DATE OF BULLETIN:

10-9-2017

MODELS AFFECTED:

SPORT CARBON HERO
PRO GTX XR
VR 200 270

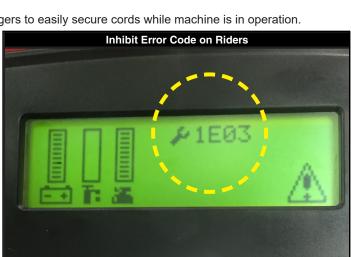
New Charger Used For:

- Onboard Chargers
- · AGM Batteries
- · International AC Voltage
- · California CEC Specifications

All machines include new yellow steel cord wrap with Delta Q Chargers to easily secure cords while machine is in operation.

Walk Behinds with an Onboard Delta Q Charger feature an internal inhibit switch and a new light on the dashboard of the CC to illuminate when the equipment won't move due to charging.

Riders with an Onboard Delta Q Charger do not feature a new light, but instead trigger an inhibit error code on the LCD when operator is charging unit and trying to drive.
